**WHITE LAKE TOWNSHIP
INTER-OFFICE MEMORANDUM**

**SUBJECT: White Lake Retail Management LLC
Preliminary Site Plan Approval**
Located on the north side of Highland Road (M-59) and west of Fisk Road.
Consisting of approximately 1.8 acres. Currently zoned (GB)
General Business. Identified as tax parcel 12-23-201-010.

RE: 9328 Highland Road- Commercial Building with Drive Thru- Preliminary Site Plan Review – 1st Review

Subject: 9328 Highland Road
Preliminary Site Plan Review
Zoned: General Business (GB) District

DRAWING:
C-6

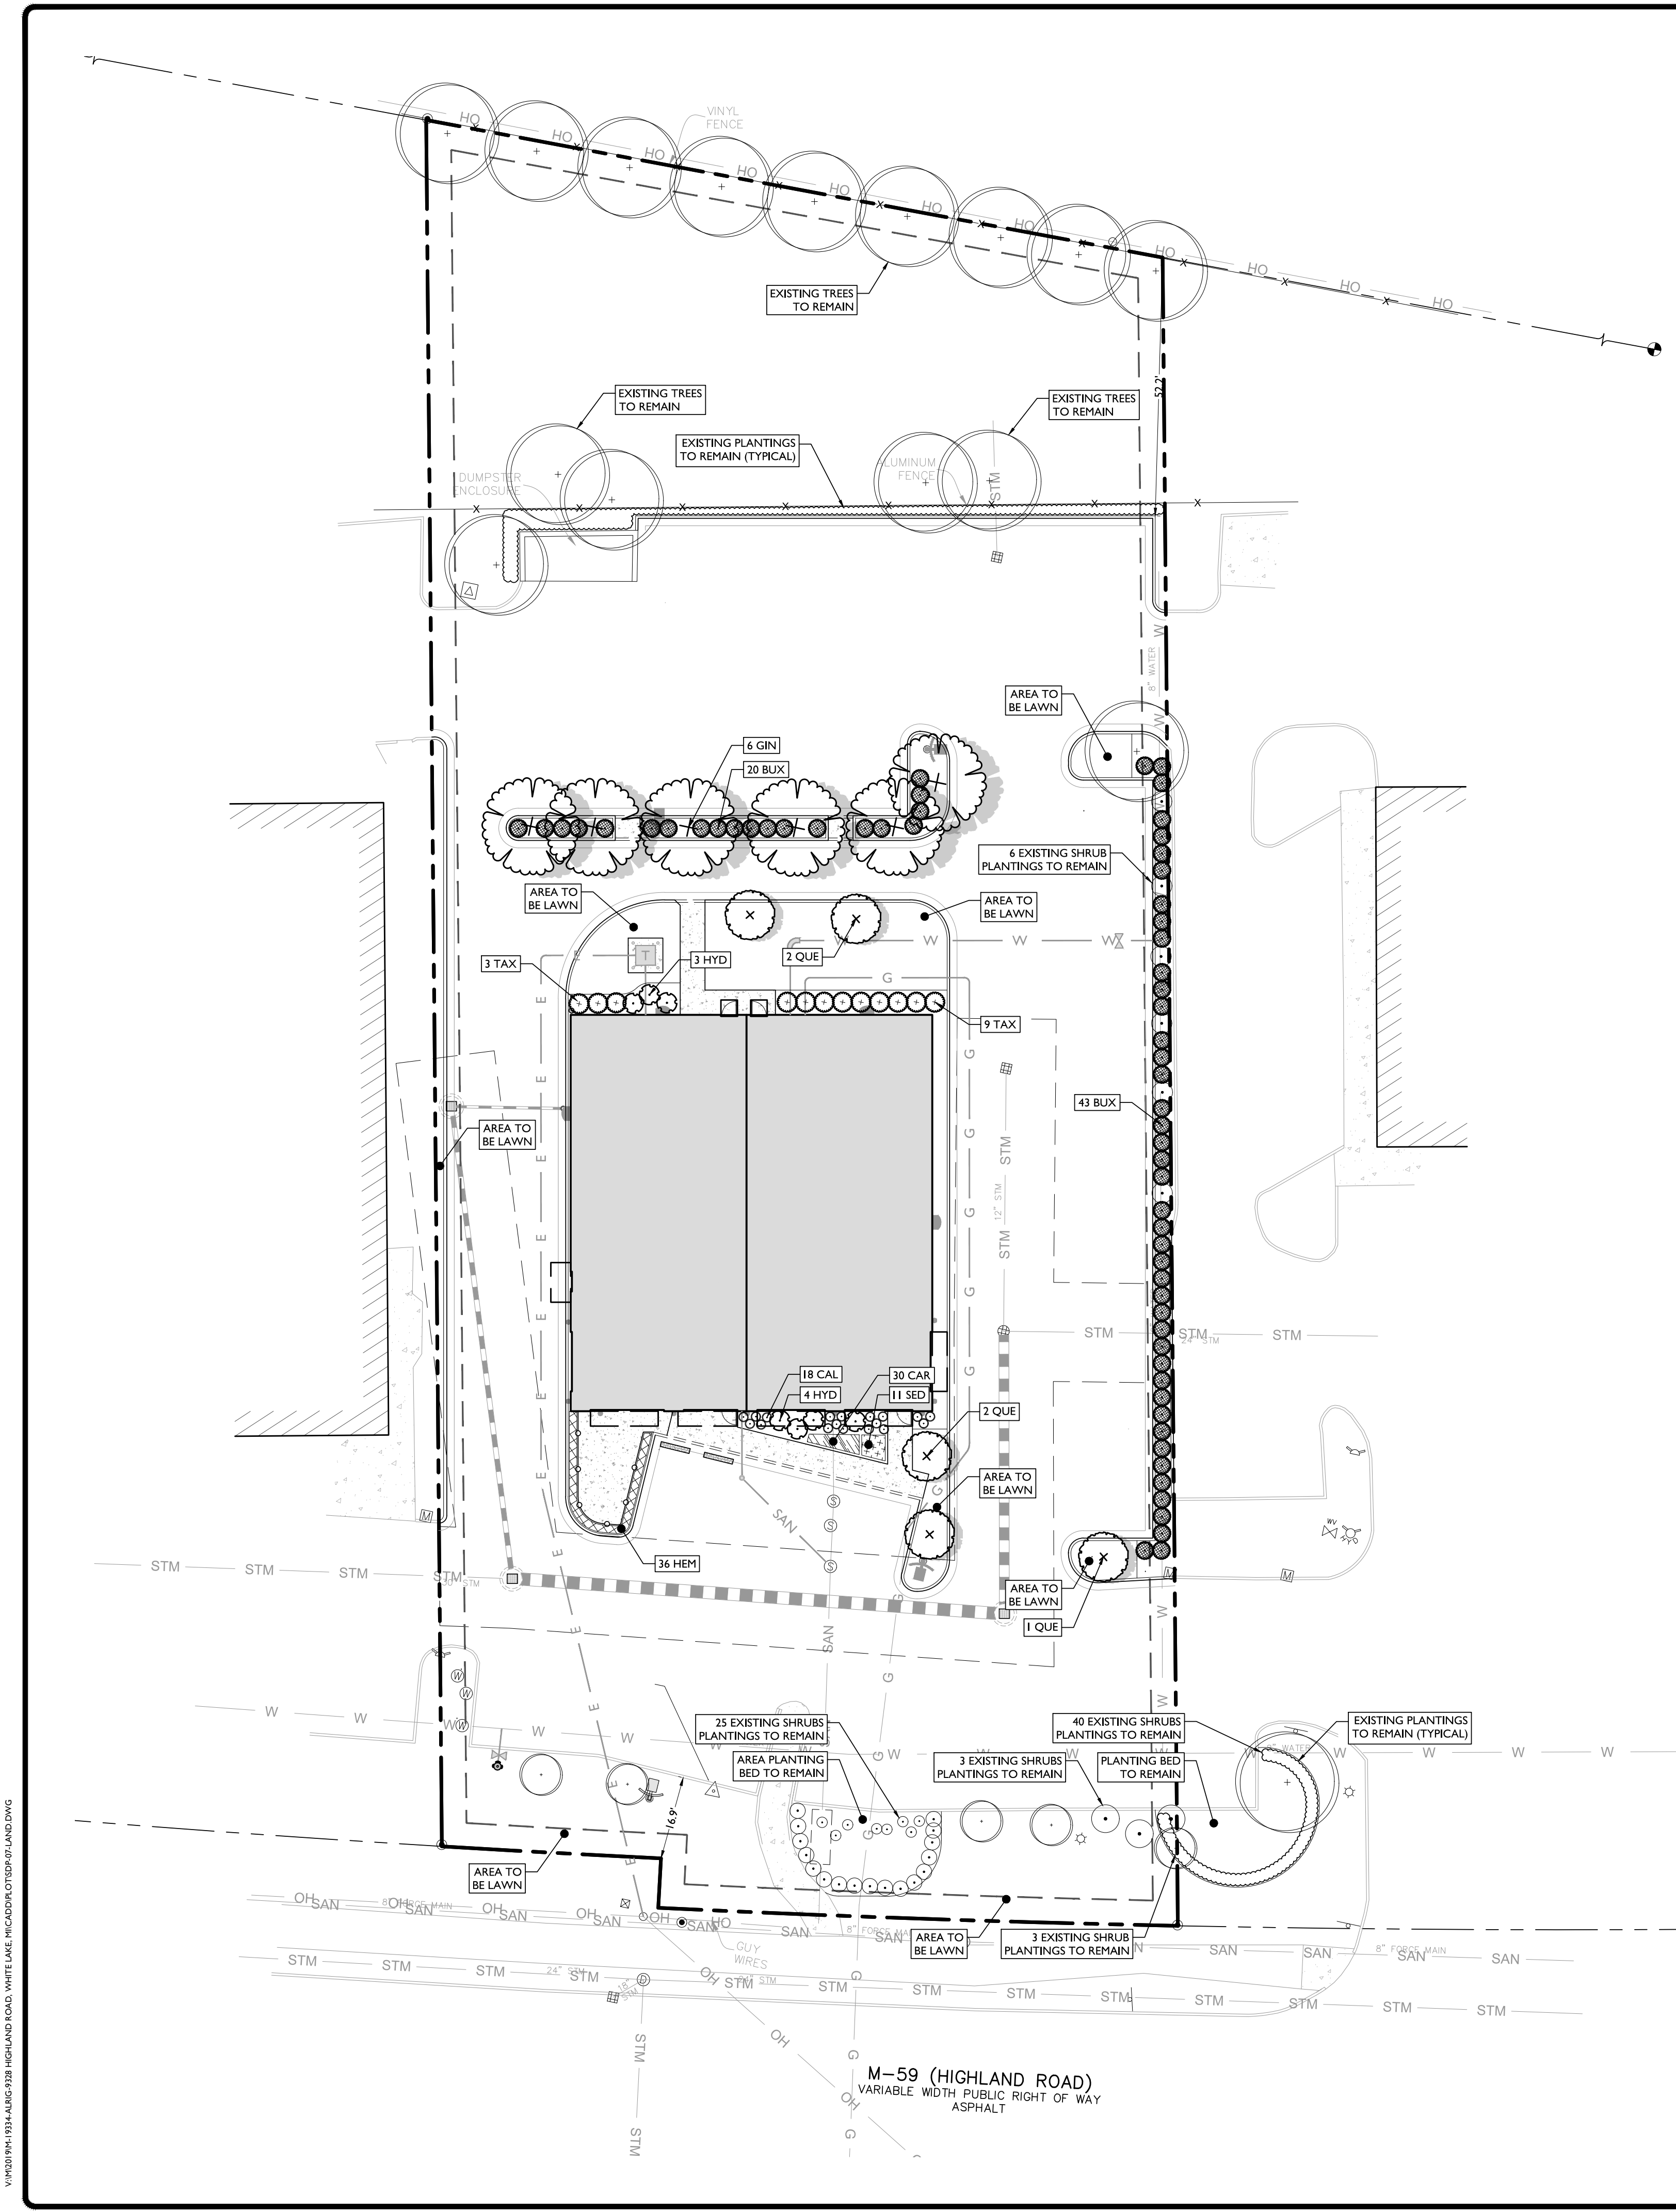
7. **Lighting.** Section 5.18(G) of the Zoning Ordinance includes the standards for outdoor lighting. A photometric plan was submitted. The plan states that the maximum foot candles at the property line exceed the permitted maximum of 1-foot candle and a notation that this is an existing light level. **The Planning Commission should determine whether or not this level of light is acceptable because it is existing.** The highest light levels occur along the front lot line by an existing pole light and a (proposed) relocated area light. If any existing fixtures are relocated or replaced, they should be brought into compliance with ordinance standards,.

Nine, rubbed bronze anodized sconce fixtures are proposed on the building. Article 6, Section 6.8.E.vii of the Zoning Ordinance states *floodlights, wall pack units, and other types of unshielded lights, and lights where the lens or bulb is visible outside of the light fixture are not permitted.* The intent is wall-mounted decorative or architectural lighting must be fully shielded and directed downward – up-lighting or outward shining lighting are not permitted. **The petitioner should revise the proposed light fixtures with those that meet the Ordinance requirements.** Four wall packs are proposed; two on the rear elevation and one on each side elevation. These wall packs are in compliance with the Ordinance as they are directed downward.

9. Dimension of existing pathway along Highland Road added to final site plan.
10. Determination by the Planning Commission as to the appropriateness of the existing level of lighting, which exceeds the Zoning Ordinance maximum for foot candles at the lot lines and internally within the site.

11. The petitioner should revise the proposed (wall sconce) light fixtures with those that meet the Ordinance requirements.
12. The applicant to provide detail on the wall sign calculations with respect to the front façade area and the area of the proposed wall signs.

DRAWING: **C-7**

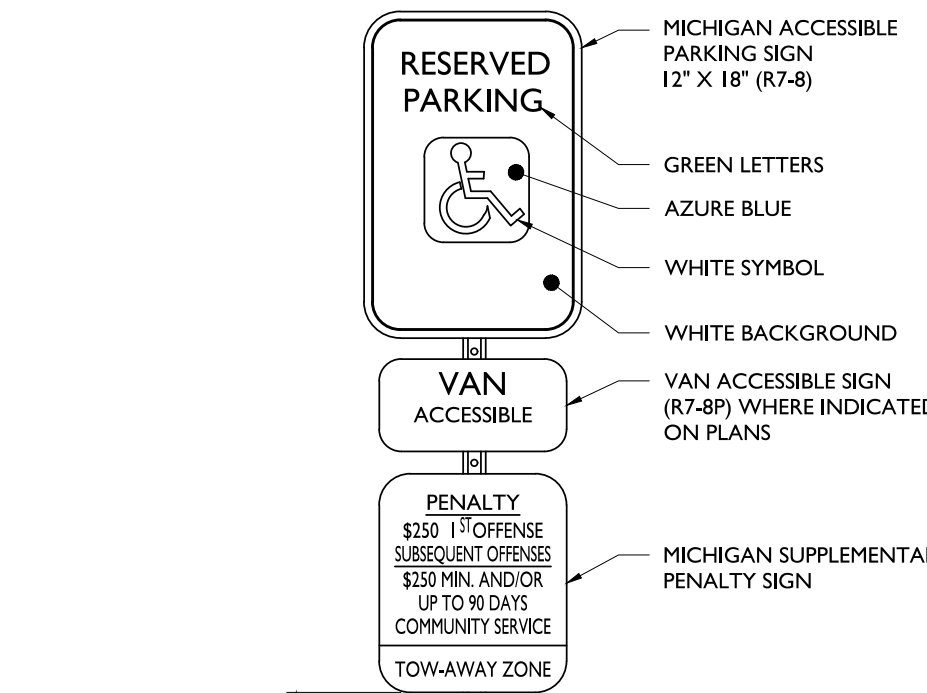
A greenbelt is required on the west and east side lot lines. A four-foot-wide landscaped area (with boxwood shrubs) is proposed on the east lot line. No buffer is proposed on the west, although there is an existing shrub buffer on the Discount Tire site at this shared property line. Again, the applicant's plan states that this is an existing nonconformity. **The Planning Commission should determine if this is appropriate and give direction to the applicant.** Typically, landscape plans are not required at preliminary site plan review, therefore, any direction should be incorporated into the final site plan review landscape plan.

Three notes should be added to the landscape plan:

- A note guaranteeing a two-year guarantee and bond for such for all new plant materials; and
- A note that all landscaped areas that abut parking areas will be separated with a 6-inch curb; and
- A note that any landscaping materials that are in poor condition will be removed and replaced with materials that meet the Zoning Ordinance requirements

5. Determination by the Planning Commission as to the lack of a buffer on the west side of the site.
6. A note on the plan regarding a two-year guarantee and bond for such for all new plant materials.

TRASH ENCLOSURE DETAIL
 SCALE: 1/2" = 1'-0" 7

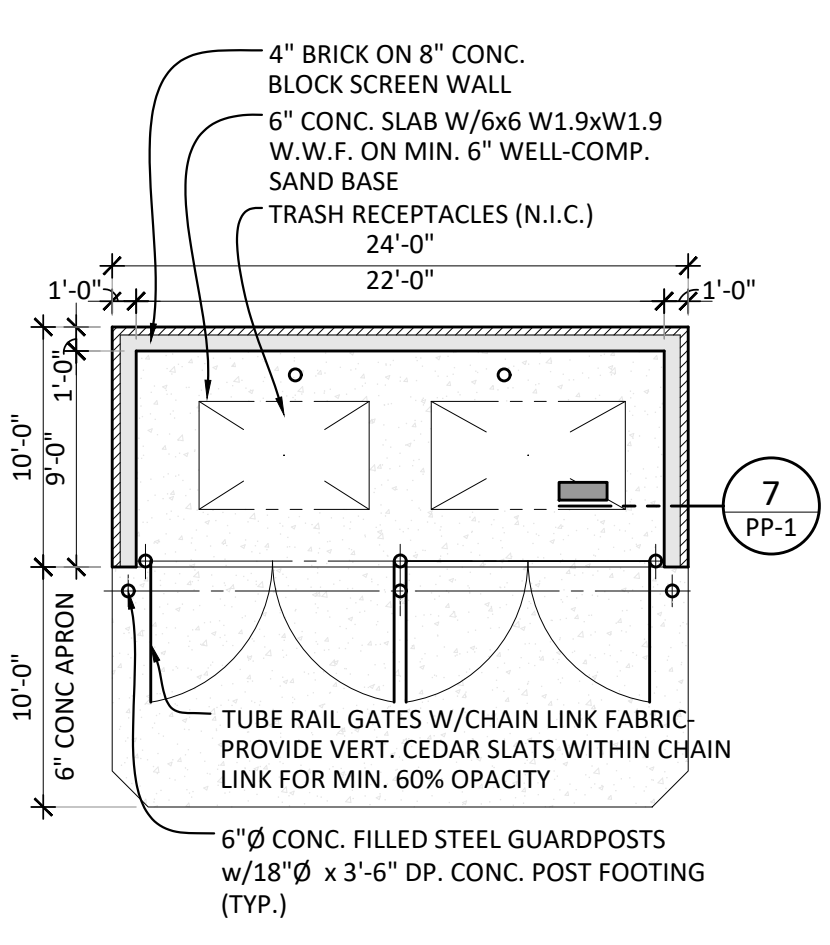
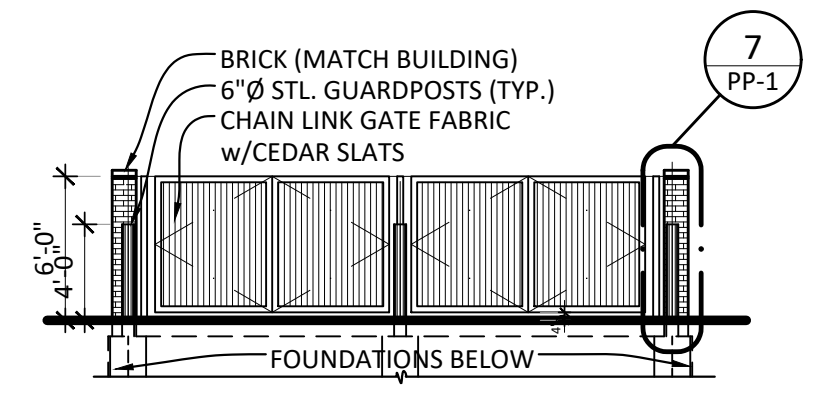
9. **Trash Disposal.** The applicant is proposing to utilize the existing 9-foot by 22-foot trash enclosure. The enclosure consists of brick veneer on a concrete block screen wall on a 6-inch concrete slab. The enclosure gate is chain link gate fabric with cedar slats. The Zoning Ordinance requires *dumpster enclosures to be constructed of the same decorative masonry materials as the buildings to which they are accessory.* The enclosure is brick veneer; however, the brick is not the same as the brick on the building. **The Planning Commission should determine if this is appropriate, as it is existing.**

13. Address of the businesses being added to the monument sign in letters at least 6 inches in height,
14. Determination by the Planning Commission as to the utilization of the existing trash dumpster enclosure.

MONUMENT SIGN
 SCALE: 1/2" = 1'-0" 6

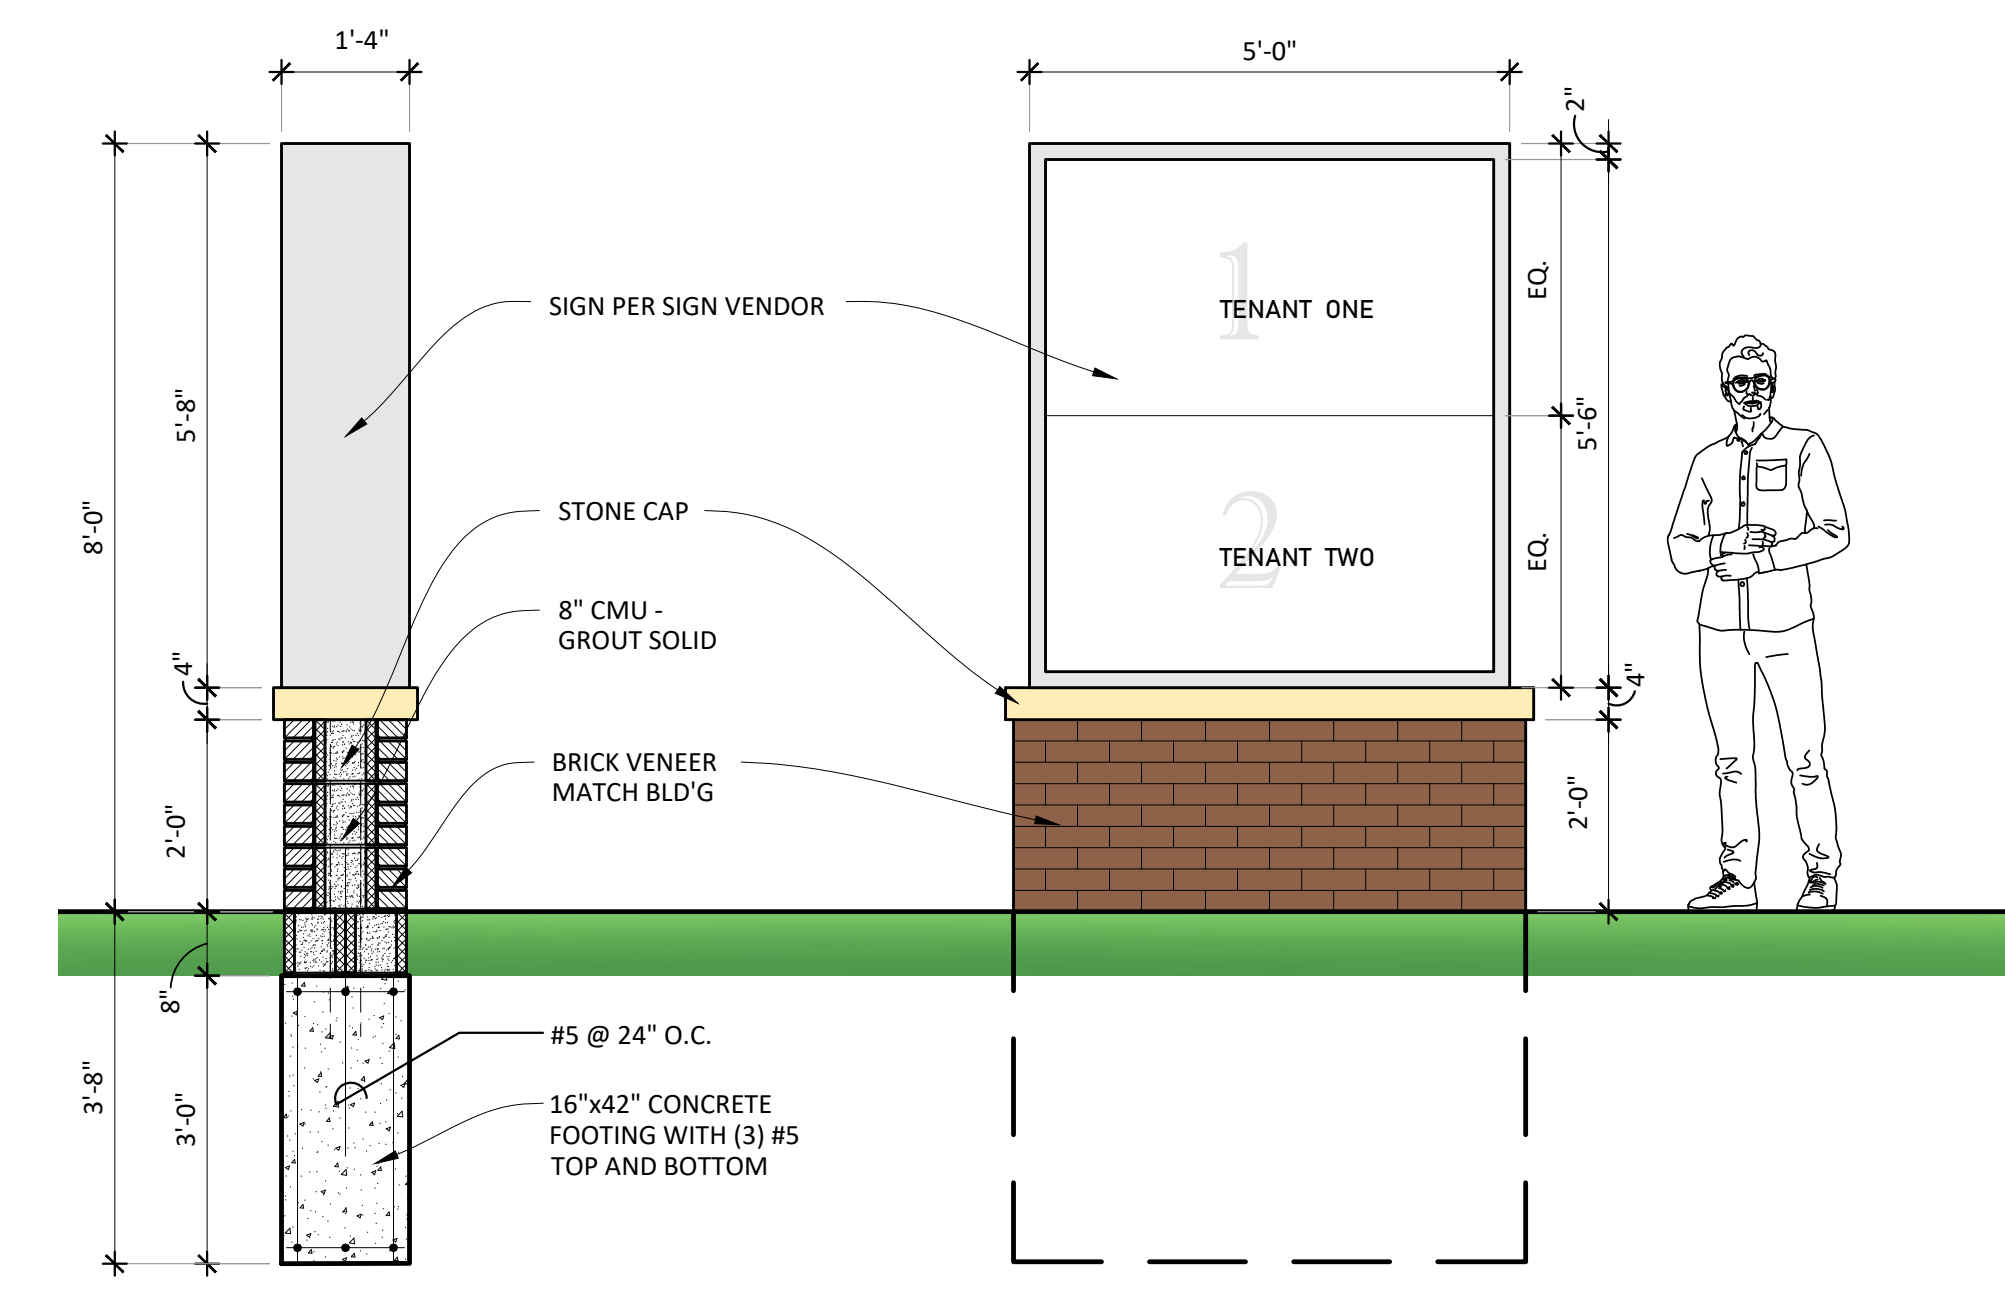
8. **Signs.** Section 5.9 of the Zoning Ordinance regulates signs. The site plan indicates one monument style sign along the Highland Road frontage. The sign is 7'-6" in overall height and 5' wide. The base consists of brick veneer to match the building with a stone cap. The size of the actual sign area is 27.5 square feet per side, which is in compliance with the Zoning Ordinance.

The Zoning Ordinance permits two wall signs for this development. If a parcel has in excess of 250 feet of frontage, an additional wall sign may be permitted. Additionally, if a building has frontage on two thoroughfares, they can have additional signage. This parcel has 148 feet of frontage and does not have frontage on any thoroughfare other than Highland Road. The two side elevation wall signs are not permitted. **At final site plan review the applicant should provide detail on the wall sign calculations with respect to the front façade area and the area of the proposed wall signs. Lastly, the monument sign must have the address of the businesses on it in 6-inch high figures.**
